Serra Mesa Community Plan Amendment – Franklin Ridge Road Connection

Community Plan Inconsistency

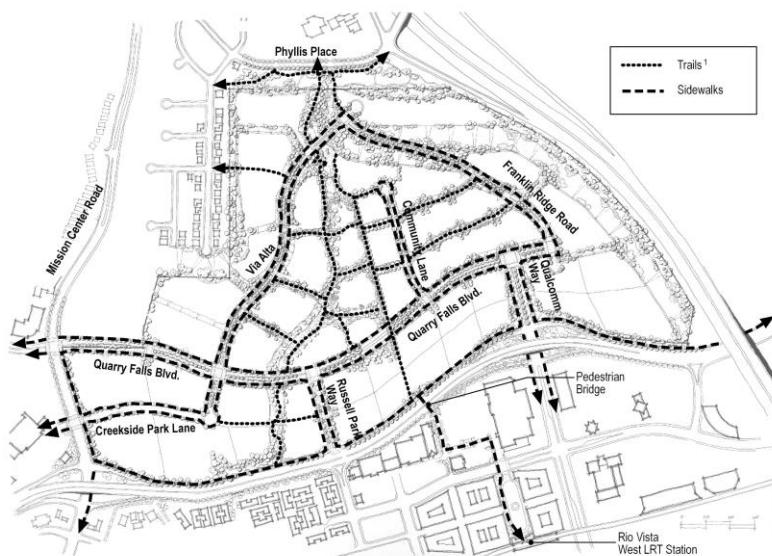
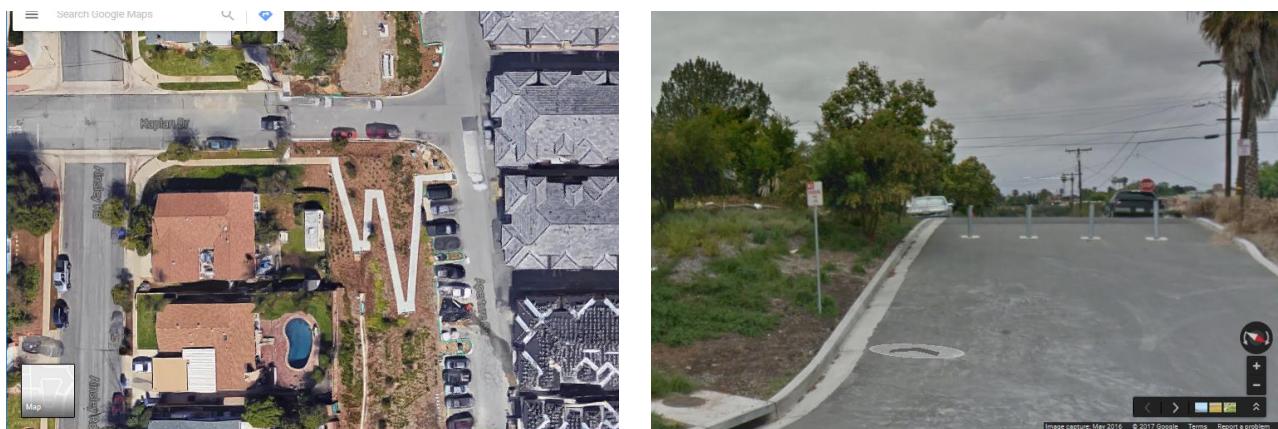
Street linkages from Serra Mesa to Mission Valley exist with Mission Center Road and Mission Village Drive. Mission Village **not mentioned in Recirculated DEIR.**

Emergency access and sidewalks between Kaplan Drive in Serra Mesa and Aperture Circle in Civita exists. This access is used extensively by the residents of Serra Mesa and Civita. Not mentioned in Recirculated DEIR.

PEDESTRIAN CIRCULATION (Fig. 3-5)

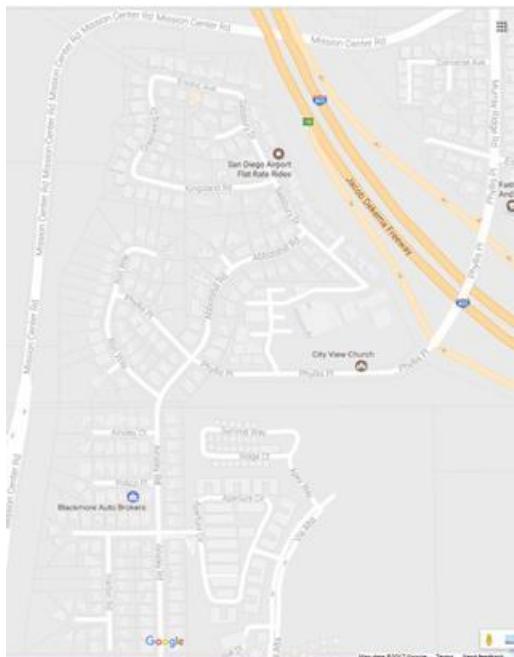
A minimum of one trail for pedestrians and bicyclists between Civita and Phyllis Place Park with or without the roadway connection is mandated. Not mentioned in Recirculated DEIR.

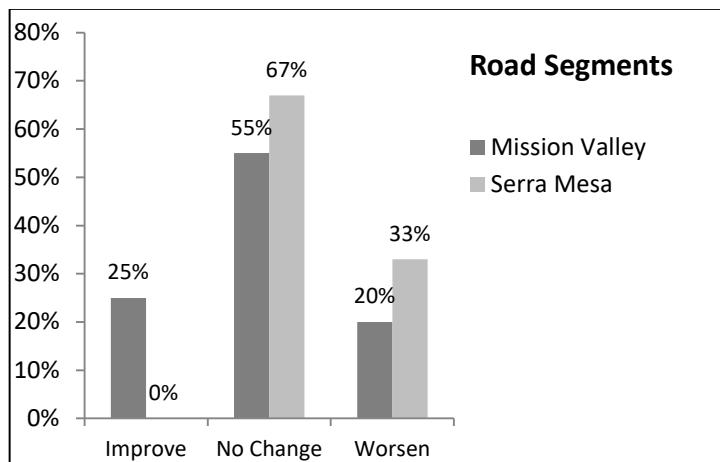
Phyllis Place – only exit for 220 homes and 56 retirement/Senior housing. Traffic congestion with road connection will impact their exit.

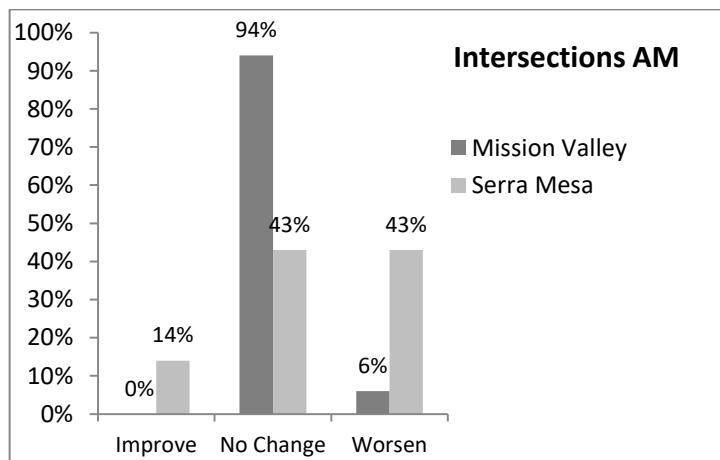
In both Serra Mesa and Mission Valley the greatest percentage of the roadway segments will receive the same LOS level. Also, in Serra Mesa $\frac{1}{3}$ of the segments will worsen and none will improve.

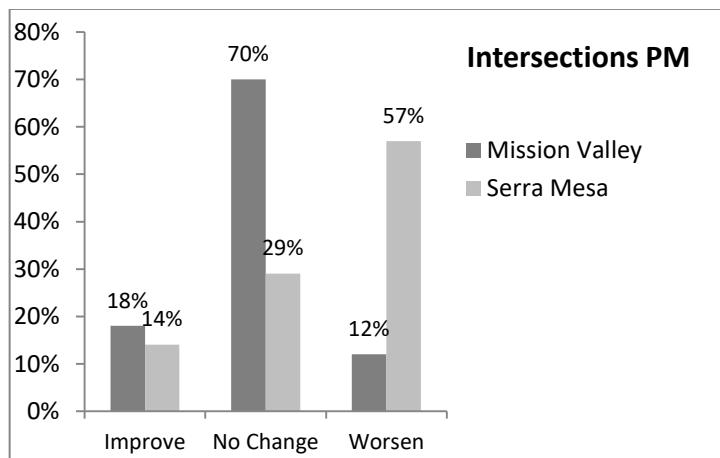
The LOS No Change is almost 100% percentage for Mission Valley while in Serra Mesa both No Change and Worsen receive the same percentage.

In Mission Valley 70% of the intersections won't change LOS level while in Serra Mesa more than half of the intersections will worsen.
